Subject: Model AP-300 Type A Package
Docket No. 71-9192

This is in response to questions in your letter, dated March 20, 1985, in which you requested additional information on our application for certificate of compliance for our Model AP-300 Shipping Container. We have responded to your questions and have made the appropriate revisions in the text of our safety analysis report.

RESPONSE TO QUESTIONS

FIGURE 2.4-3 TIE-DOWN CONFIGURATION

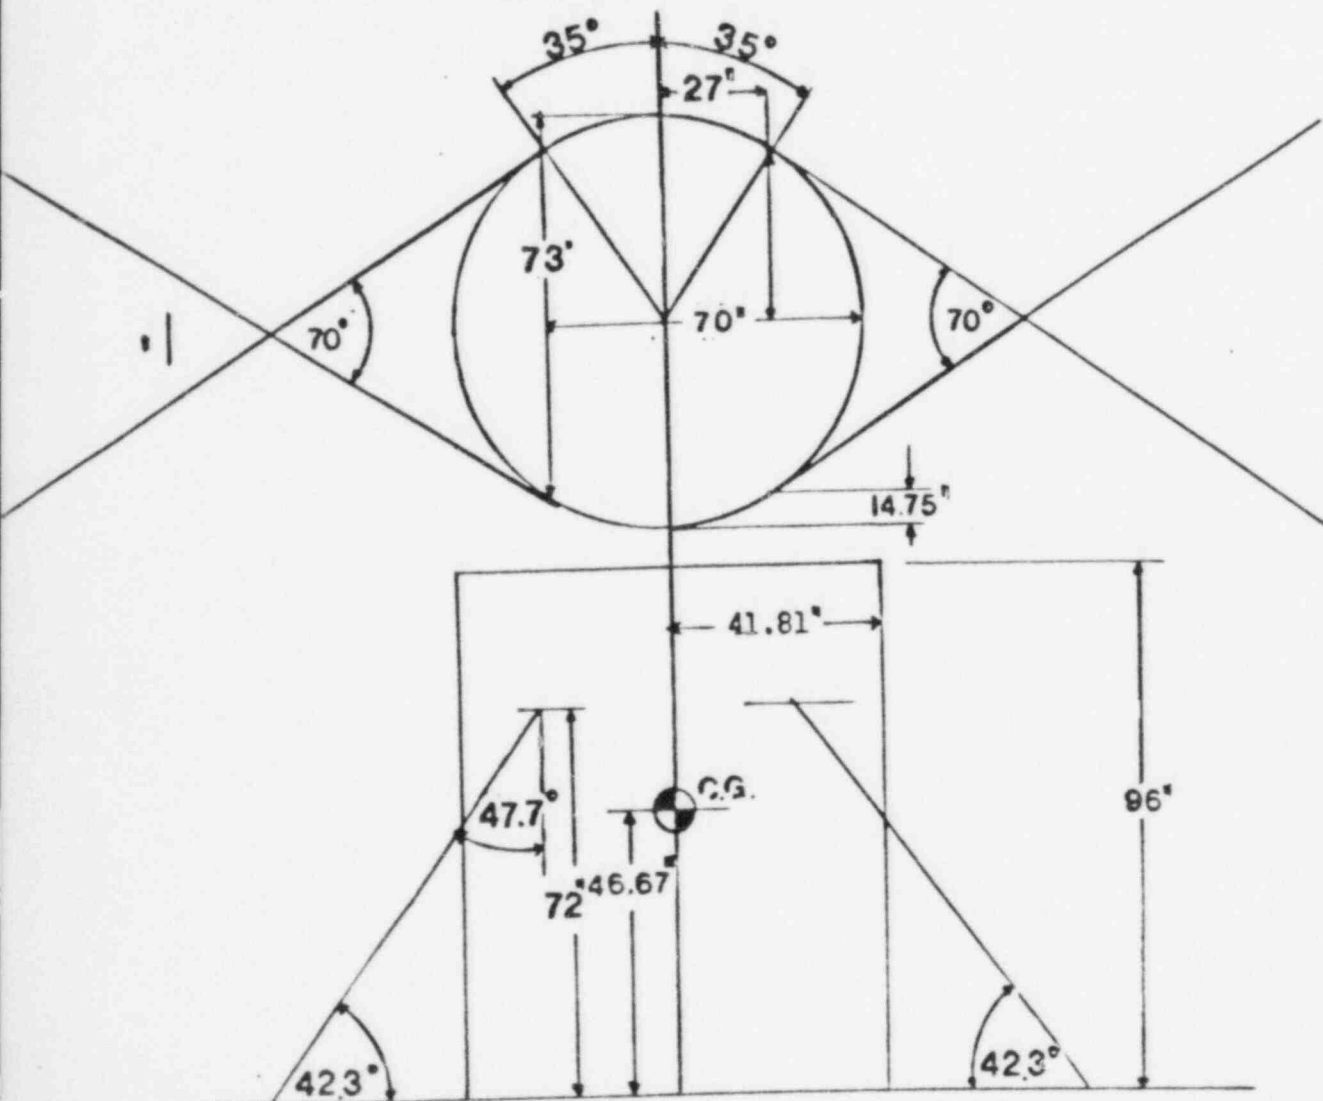
Since the tie-down lug makes an angle with both the horizontal and vertical axis, the force applied to the lug should be adjusted for these angles. Please revise your calculation.

Ans. The tie down lug makes an angle of 42.3° with the horizontal, as shown in Fig. 2.4-3. The design of the tie-down is based on the capability to withstand the simultaneous vertical, forward horizontal and sideward horizontal g forces, specified in 10CFR 71.31. As shown in Section 2.4.4.1, this resultant force is 748.9 kip. We have added text and calculations to Section 2.4.4.1 which identify that the maximum resultant force imposed on each tie-down lug will be 187.2 kip. The equivalent horizontal and vertical components of this force are shown to be 138.5 kip and 126.0 kip, respectively. In the calculations to verify the adequacy of the pad design, it is shown in Section 2.4.4.5.2 that the tie-down design is adequate, with a large margin of safety, even for the greater resultant force.

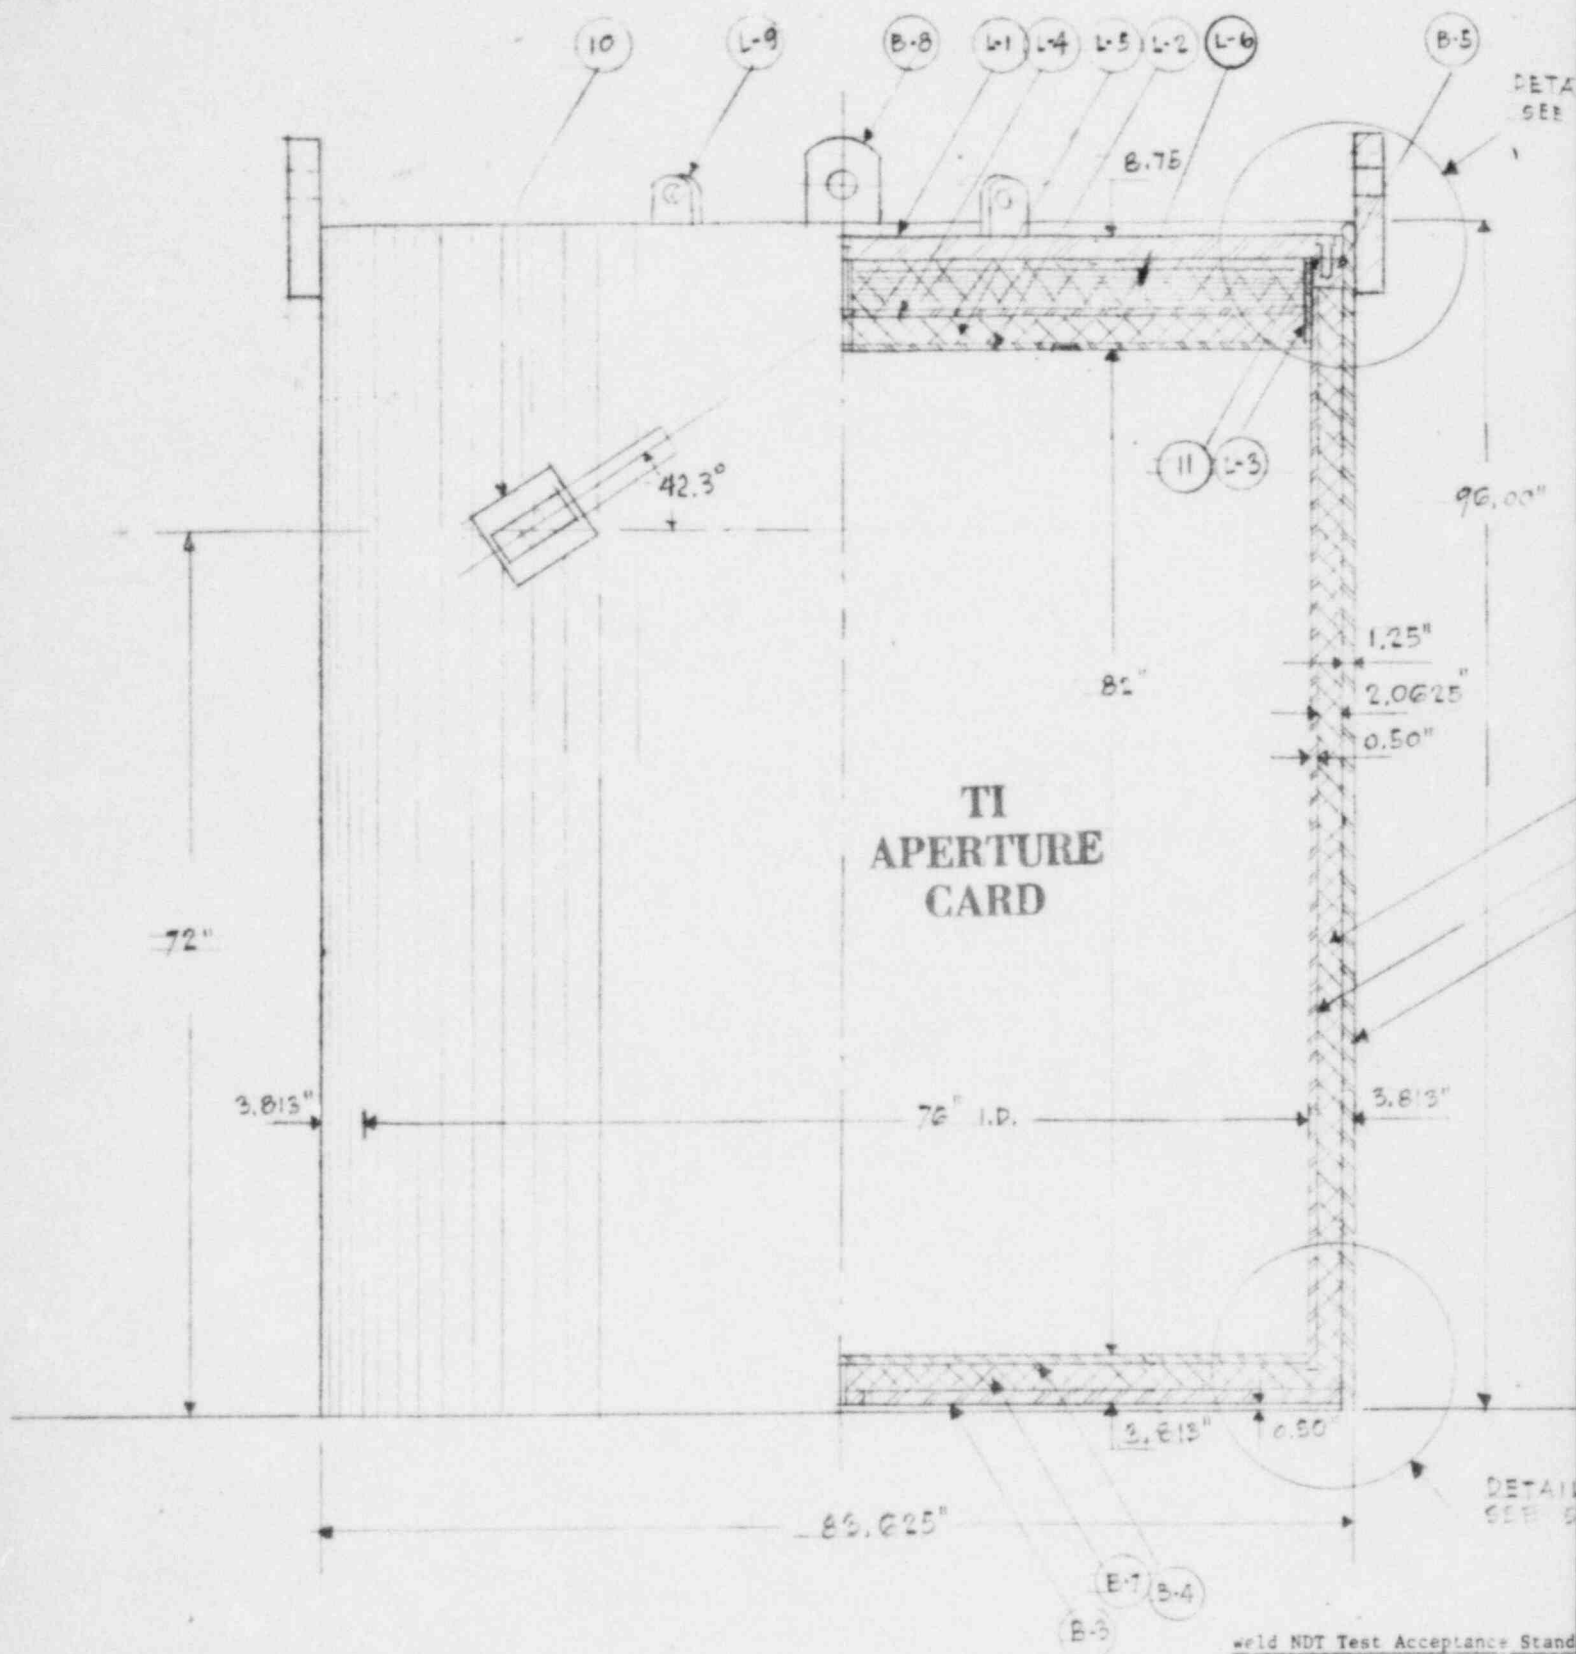
Drawing Nos. 139-1 and 146-1. Completely specify the gasket material on the drawings.

Ans. Drawing Nos. 139-1 and 146-1 have been revised. Rev. 1 of each of these drawings specifies that Manville Red Devil Style 940 will be used as the gasket material.

DRAWING NUMBER
133-1 REV. 3

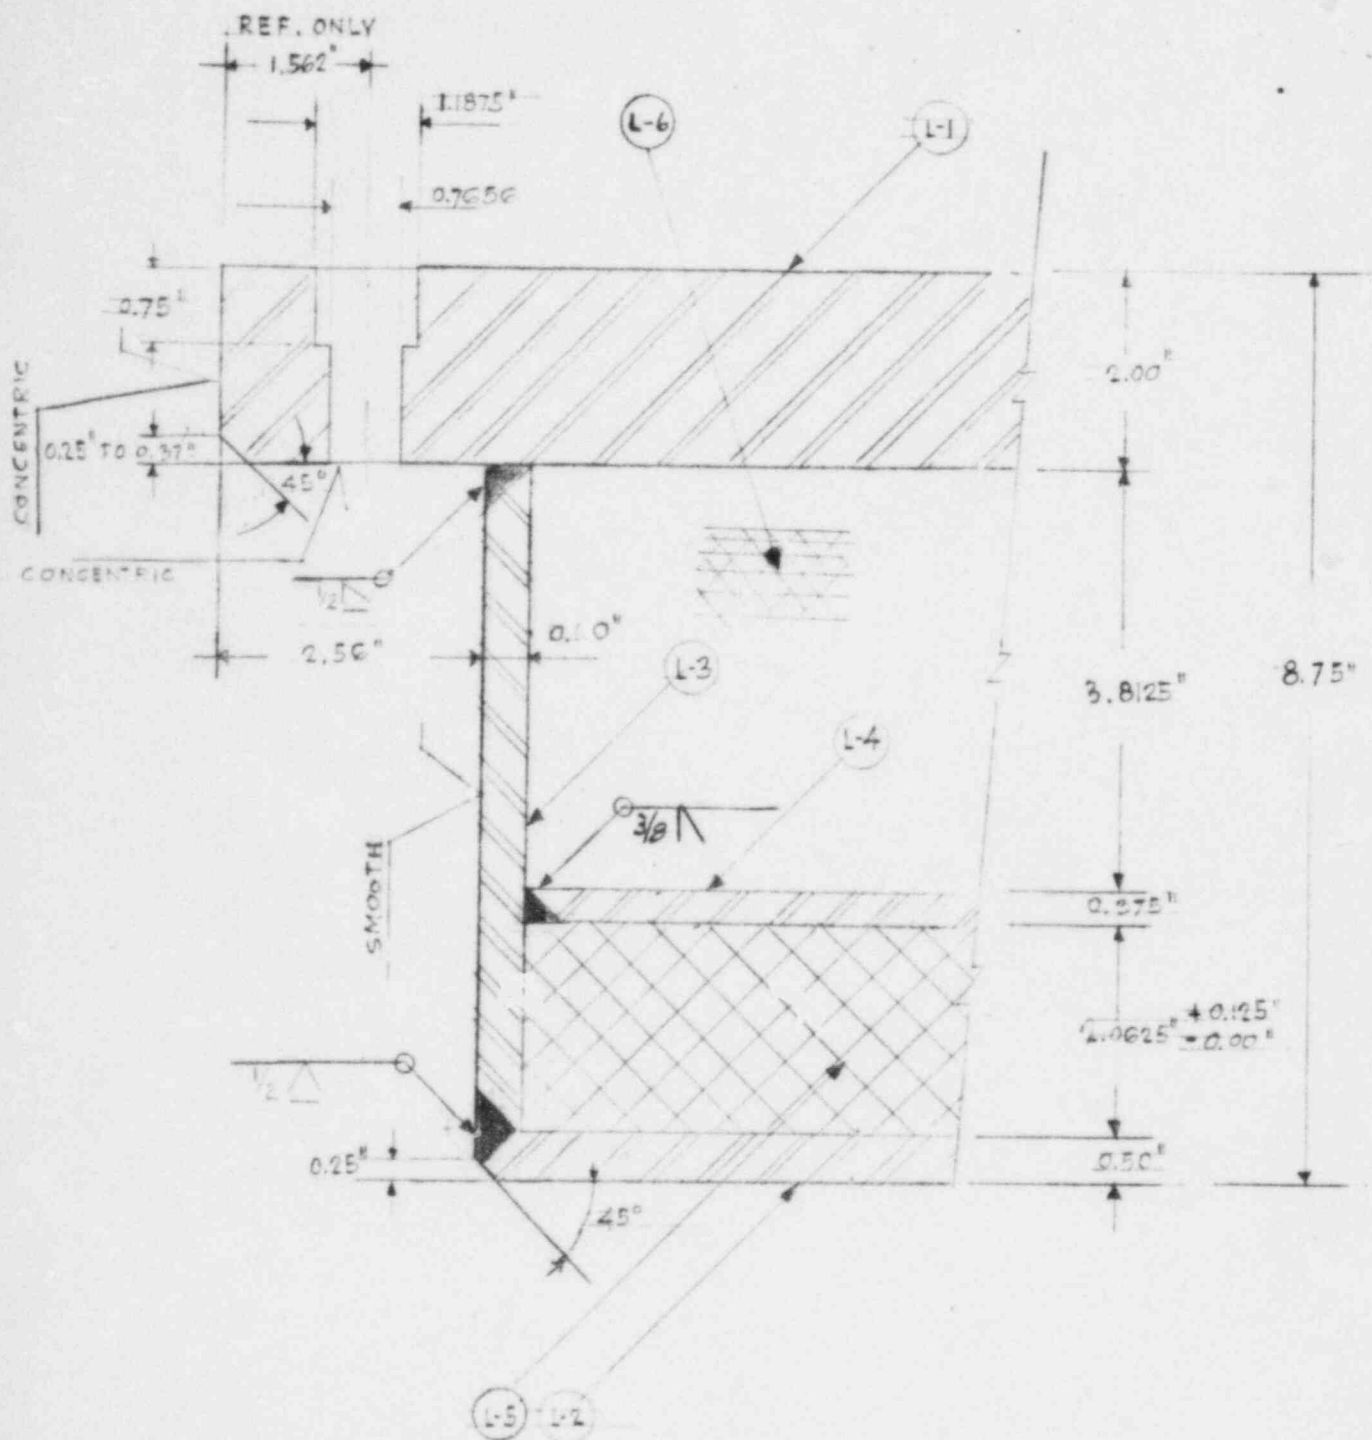
The tie-down lugs and pads were evaluated based on a yield stress of $F_y=60$ Ksi. However, Drawing No. 133-1, Rev. 2 specifies that the tie-down lugs are A516 Grade 70 which has a yield stress of $F_y=38$ Ksi. Please revise the analysis. Also, it should be shown that the reinforcing pad is adequate for its intended purpose.

Ans. A yield stress of $F_y=38$ Ksi was used in the revised calculations. The safety factor for bearing and shear of the pad was calculated to be 1.52 and 2.03 respectively, so that the pad is adequate.

LID AND LID FINISH

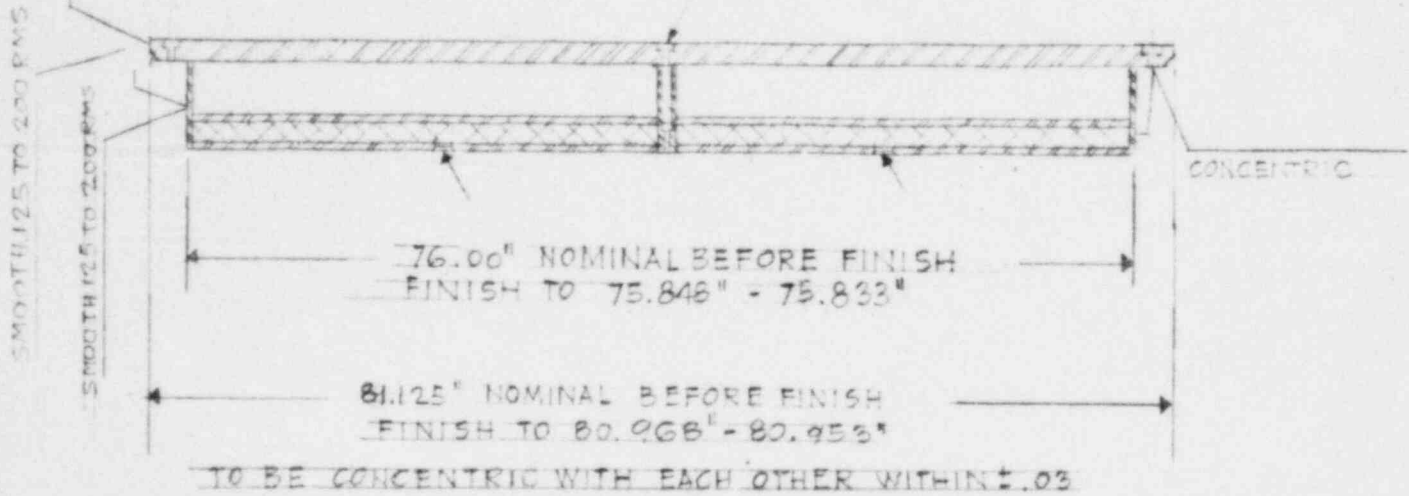
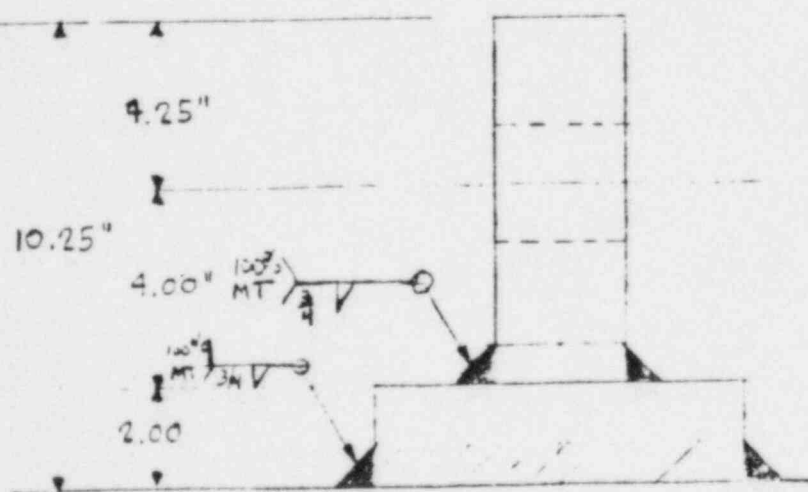
Drawing No. 135-1, Rev. 3. The weld joining part L-3 to L-4 needs clarification. Picture shows a bevel weld and the weld symbol calls for a fillet weld.

Ans. Drawing No. 135-1 has been revised. Rev. 4 shows a bevel weld symbol for the joint between parts L-3 and L-4.

ANEFCD		904 Ethan Allen Hwy. P.O. Box 433 Ridgefield, Conn. 06877	
SCALE AS NOTED	APPROVED BY	DRAWN BY C.C.	
DATE 10-21-82			
AP-300 CASK			
TIE-DOWN PAD (4 PLACES)		DRAWING NUMBER 138-1 REV. 4

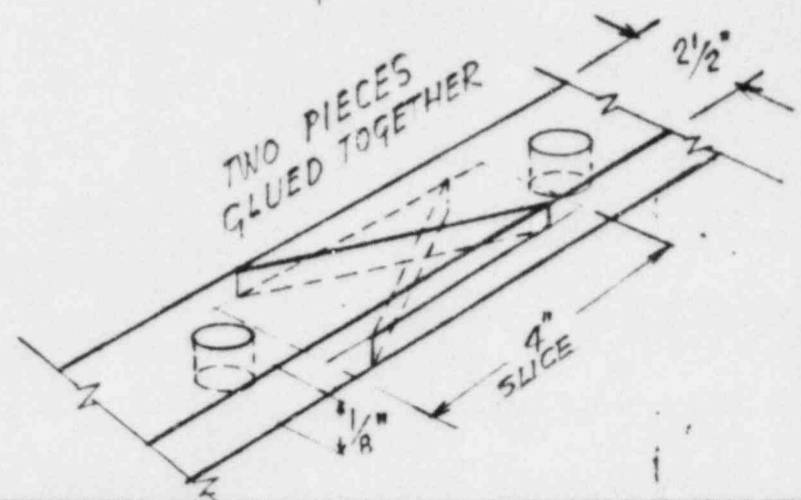
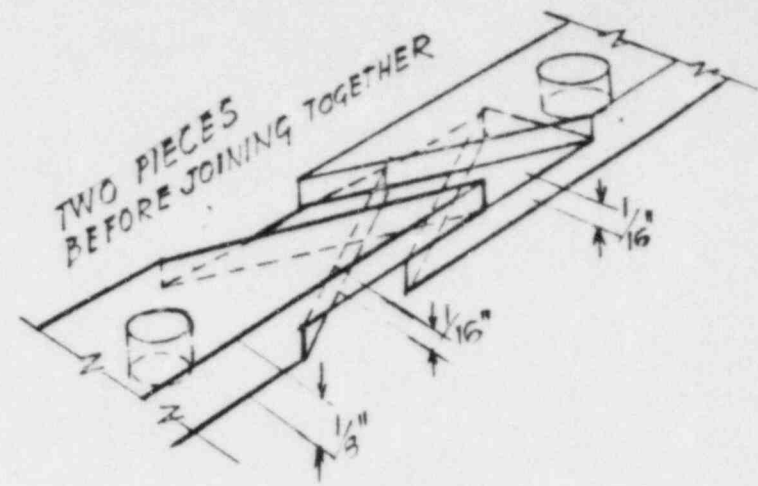
Drawing No. 138-1, Rev. 3. The size of the weld joining item 10 to the outer shell should be given in the weld symbol. The detail of the identification plate should provide line titled Package Identification No.

Drawing No. 138-1, Rev. 3 shows 3/4" fillet welds for the tie-down devices while the analysis has assumed full penetration welds. The analysis should be revised accordingly.

Ans. Drawing 138-1 has been revised. Rev. 4 provides a line for "Package Identification No." and identifies a 3/4" weld as joining item 10 to the outer shell.

Ans. The calculations in Section 2.4.4.5.2 have been revised and analyze the use of 3/4" fillet welds applied to the tie-down pads.

1 CHANGED WELD TO 3/8" - ADJ REV BUD		13	3/15/83
NO REVISIONS		APPR	DATE
ANEFECO		904 Ethan Allen Hwy. P.O. Box 433 Ridgefield, Conn. 06877	
SCALE: 1/2" = 1"	APPROVED BY	DRAWN BY C.C.	
DATE: 4-8-83			
AP-300 CASK			
HOLES IN LEAD COVER		DRAWING NUMBER 143 - 1 REV. 1

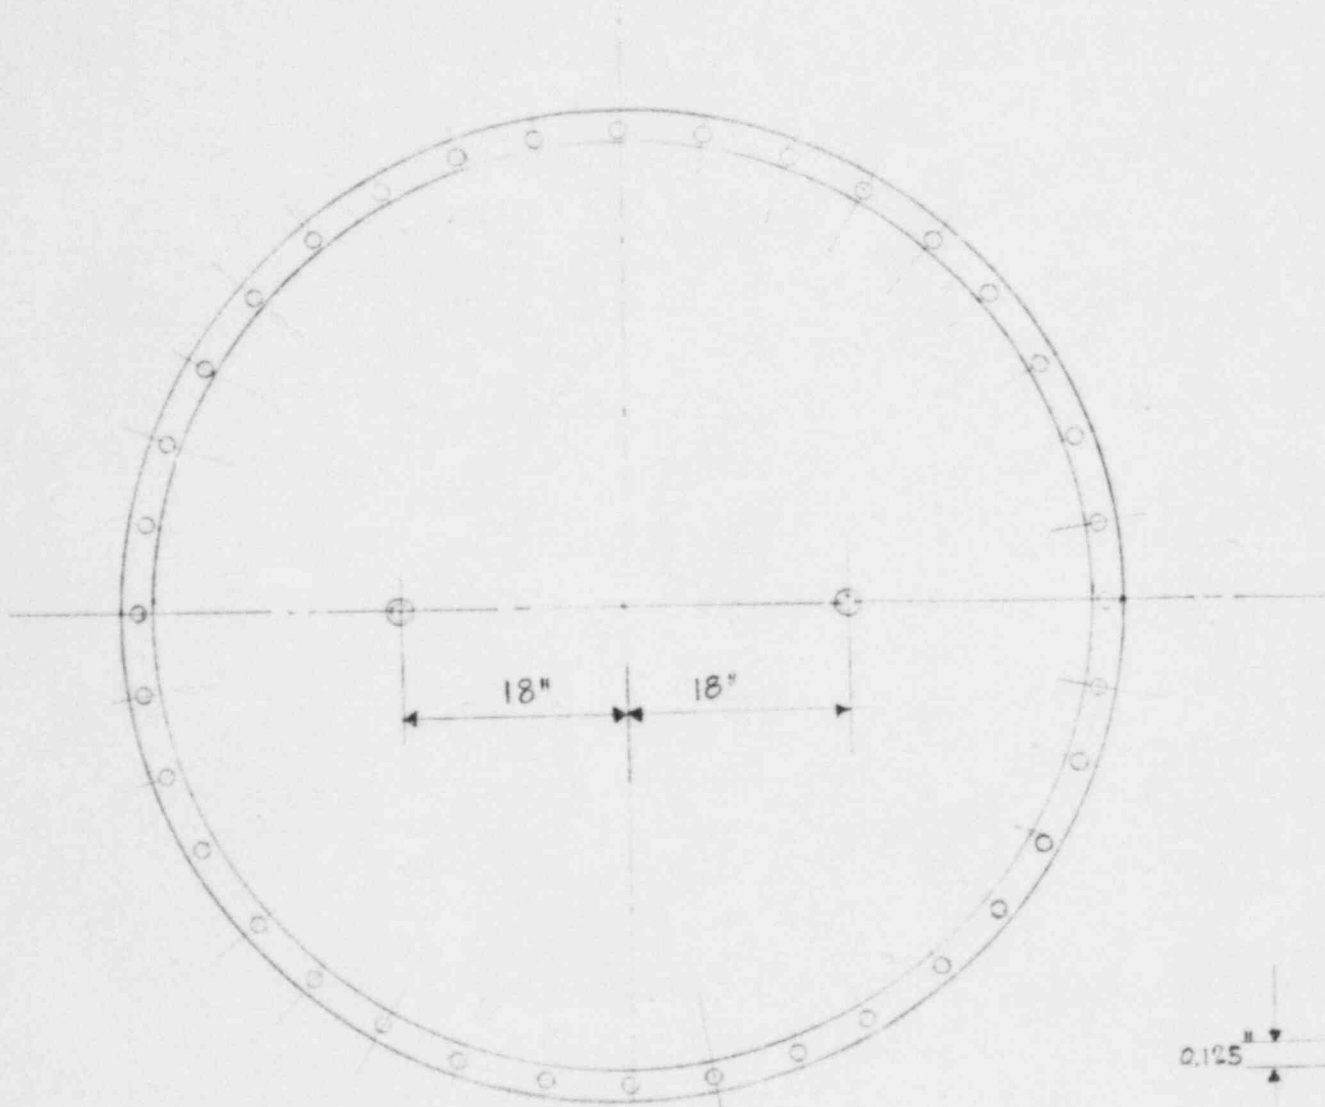
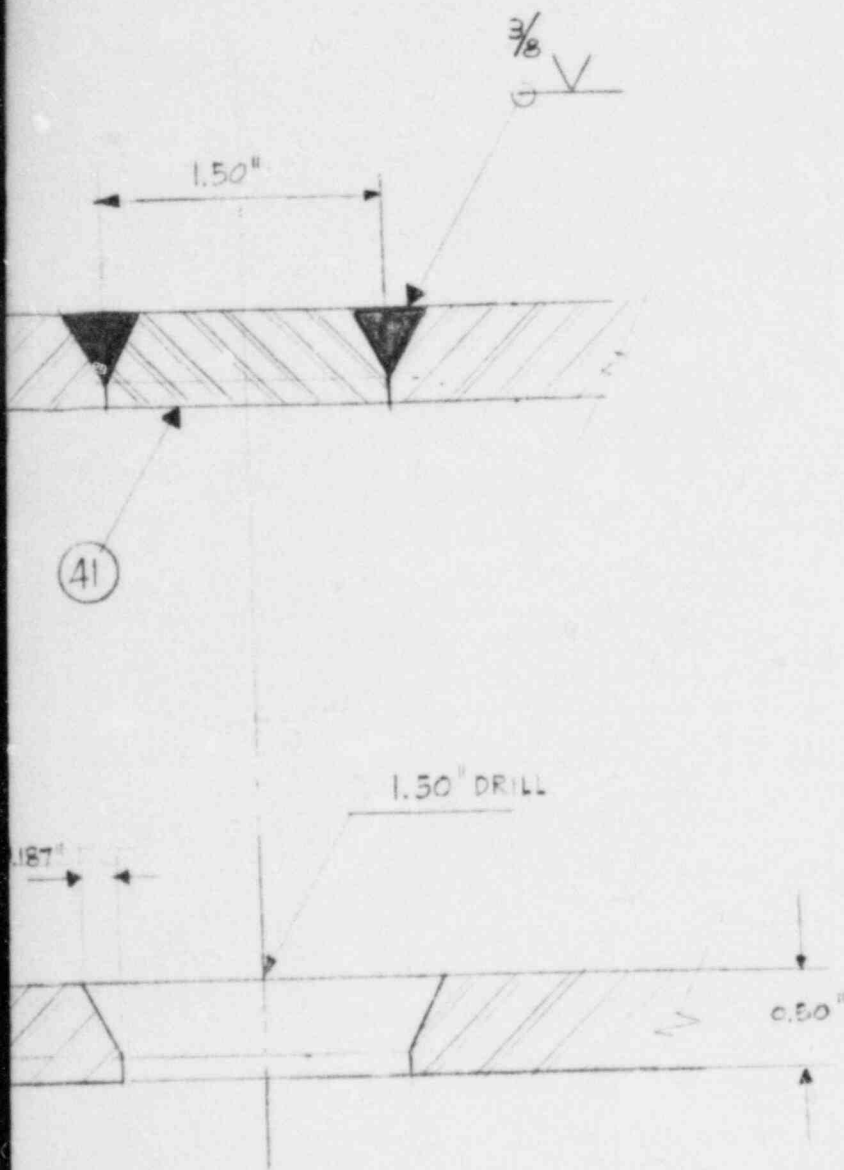
Drawing No. 143-1. It is noted that the weld symbol specifying the joint between Item 41 and L-2 calls for a 3/4" bevel weld in a plate which is only 1/2" thick.

Ans. Drawing No. 143-1 has been corrected. Rev. 1 specifies a 3/8" weld for the joint between Item 41 and L-2.
